Access Compliance Report

Public Rights-of-Way

(Curb Ramps)

Intersection ID: 12448	Main Street: HOLTON_AV	Cross Street: WILKINSON_BV	Location: NW
ADA ID: CBC56A9C69C1	Ramp Type: ParaDiag	Initial Pass/Fail: Fail	Overall Compliance: No
Severity Score: 12.5			
Codes/Mitigation Info/Possible Solution		Field Measurements/Component Compliance

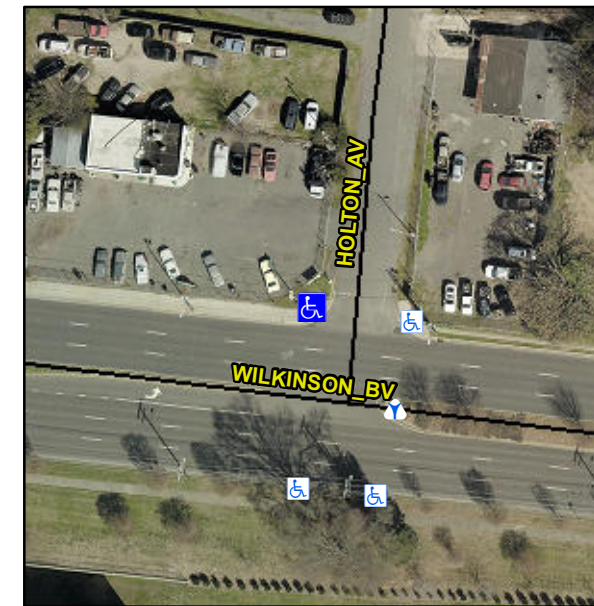
LT RP < 5%

R304.3.2

Compliance	Description	Data	Compliance	Description	Data
N/A	Ramp Length LT (in)	43.0	N/A	Ramp Length RT (in)	48.0
Yes	Ramp Width LT (in)	84.0	Yes	Ramp Width RT (in)	84.0
Yes	Ramp Slope LT (%)	1.6	No	Ramp Slope RT (%)	8.6
Yes	Ramp XSlope LT (%)	0.1	Yes	Ramp XSlope RT (%)	2.0
N/A	Landing Length (in)	N/A	N/A	DWS Provided?	N/A
N/A	Landing Width (in)	N/A	N/A	DWS Contrast?	N/A
N/A	Landing Slope (%)	N/A	N/A	DWS Length (in)	N/A
N/A	Landing X Slope (%)	N/A	N/A	DWS Full Width?	N/A
N/A	Landing Curb? (Y/N)	N/A	N/A	DWS Offset (in)	N/A
N/A	Shared Landing?	N/A			
N/A	Gutter Ponding?	N/A	N/A	Gutter Slope (%)	N/A
N/A	Gutter Lip Ht (in)	N/A	N/A	Gutter X Slope (%)	N/A
N/A	Painted X Walk1?	No	N/A	Painted X Walk2?	No
	X Walk 1 Direction	To S		X Walk 2 Direction	To E
N/A	X Walk 1 Width (in)	N/A	N/A	X Walk 2 Width (in)	N/A
	X Walk 1 Slope (%)	1.2		X Walk 2 Slope (%)	4.2
	X Walk 1 X Slope (%)	1.4		X Walk 2 X Slope (%)	1.4
N/A	Ramp inside XWalk1?	N/A	N/A	Ramp inside XWalk2?	N/A

Remove & Replace Curb Ramp With Two New Directional Ramps or Equivalent.
